Camden Medical Campus Modification 1

Changes to the layout of the Camden Medical Campus
concept proposal
State Significant Development Modification Assessment
(SSD 7387 MOD 1)

May 2020

Published by the NSW Department of Planning, Industry and Environment

Figure 7 | Building Elevations and Sections (Source: Modification Report)

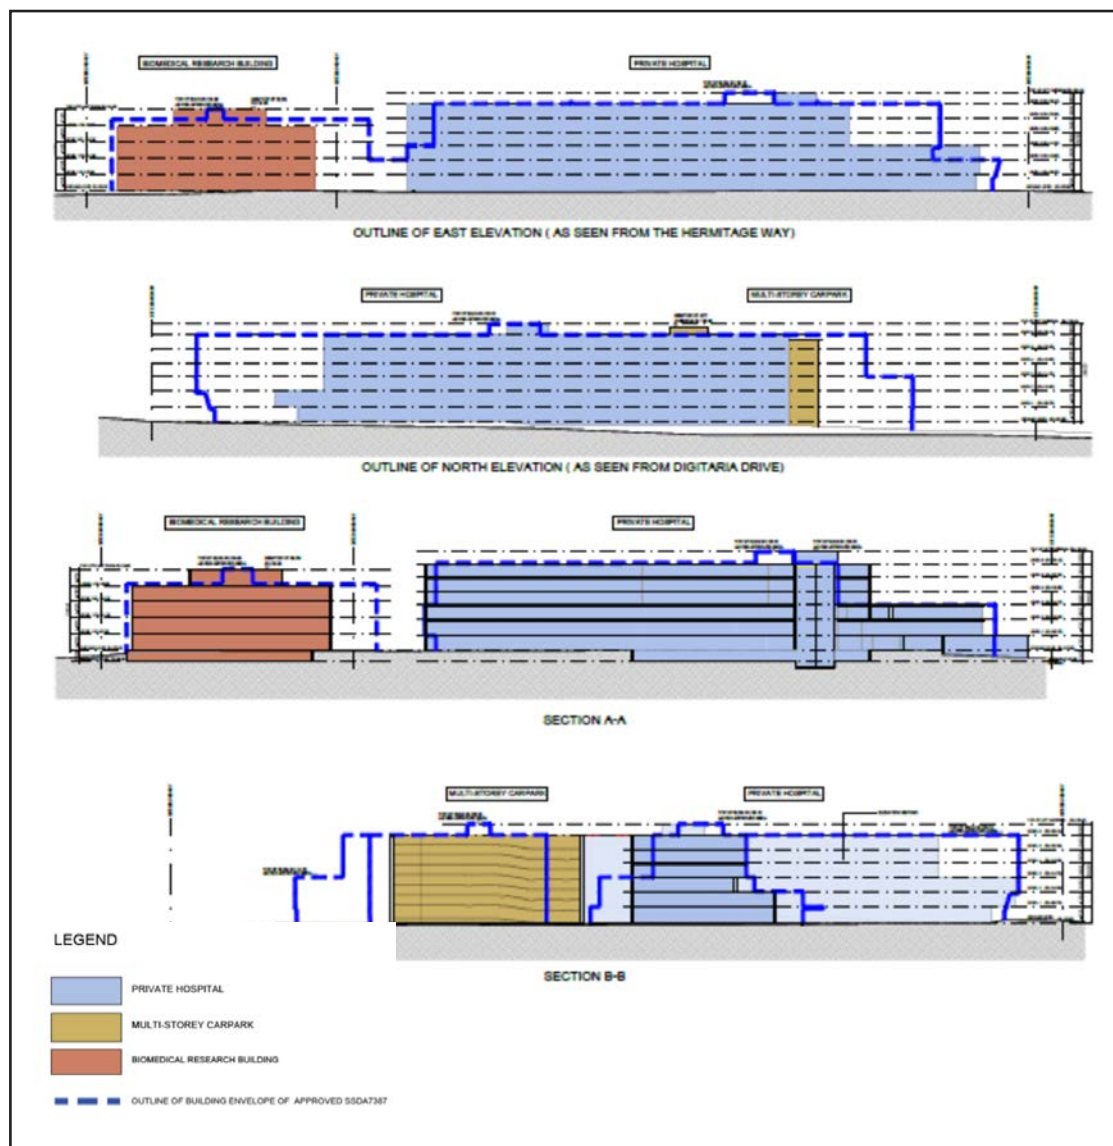
Figure 7 illustrates the proposed change in profile of the building envelopes across the site.

The proposed amendments to the building envelope will impact on the shadow cast particularly in the winter solstice (see **Figure 8**). At 9am there is a net reduction in the overshadowing, although there is additional overshadowing in the southwest corner in the riparian corridor. At 12pm, there is an overall reduction in overshadowing, while at 3pm there is a net reduction in overshadowing although residential properties to the southeast of the site will have an increased impact.

The Department has reviewed the proposed building envelope changes and subsequent impacts to shadowing and bulk and scale and is satisfied that the changes are acceptable and the overall reduction in GFA will result in an acceptable design outcome and improve user amenity, noting that detailed design issues will be dealt with in future applications.
